**Marine
Management
Organisation**

MMO Reference: DCO/2016/00005
Planning Inspectorate Reference: EN010078
Identification Number: 20024119

Planning Act 2008, Scottish Power Renewables, Proposed East Anglia Two (EA2) Offshore Windfarm Order

MMO Deadline 5 Response

Figure 2.3.2.2 a-c: North Sea herring - Abundance of larvae < 11 mm (n/m^2) in the southern North Sea as obtained from the International Herring Larvae Survey in the second half of December 2015 (a) and in the first (b) and the second half (c) of January 2016 (maximum circle size = 1 600 n/m^2).

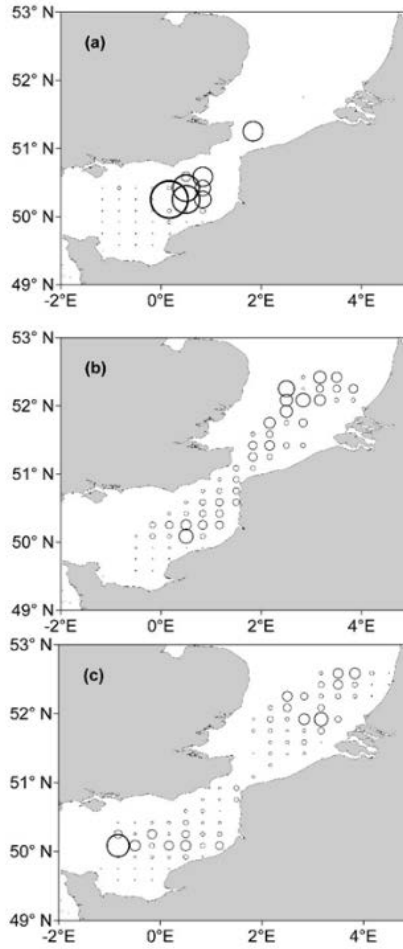
The MMO notes that the modelling presented in Figures 1 and 2 is based on a stationary receptor, using the maximum hammer energy. The MMO has assumed the hammer energy is 4000kJ though is not specified in the Applicant's response.

Figure 1. displays 10 years (2007-2017) of IHLS data for the two surveys undertaken during January each year (1-15 January and 16-31 January). Figure 2. displays 10 years (2007-2017) of IHLS data for the whole of the Downs survey period (16-31 December, 1-15 January, and 16-31 January).

Figures 1 and 2 show that there is an overlap of the noise contours for temporary threshold shift (TTS) and 150dB 'behavioural response' with northerly areas of the Downs herring spawning ground for EA2. The MMO notes for EA1N, there is a slight overlap of the TTS noise contour with the spawning ground, but as per EA2, the 150dB 'behavioural response' noise contour fully overlaps northerly areas of spawning ground.

In their current form, the maps presented in Figures 1 and 2 do not provide sufficient information to refine the period of temporal restriction. Within the ES and technical reports, the Applicant has presented a suite of maps including spawning and nursery ground maps, PSA data and IHLS data. Unfortunately, as the individual data sets have not been provided together in one map, it is difficult to interrogate and interpret to ascertain the level of potential risk to herring.

The style of 'heat map' used to present the IHLS data in Figures 1 and 2 is difficult to interpret, in terms of quantifying larval densities. It would be helpful if the IHLS heat map was presented using isopleths/contours with a colour graded key showing the different larval densities per m^2 for each isopleth/contour.

- IHLS larval density data <11mm (newly hatched yolk sac larvae) for the 10-year data set in m^2 (please see recommendations for presentation of IHLS data below).
- PSA data for the EA1N and EA2 study area (PSA data from the EA Zone would also be helpful)
- Seabed substrate British Geological Society (BGS) data with Folk (1954) classification.
- Historical herring spawning ground data (Coull et al., 1998)
- ICES rectangles
- TTS (186dB) noise contours
- 'Behavioural response' 150dB noise contours (as a substitute for 135 dB SEL_{ss})

- As a consolidated figure over a 10-year period.
- By individual survey year.
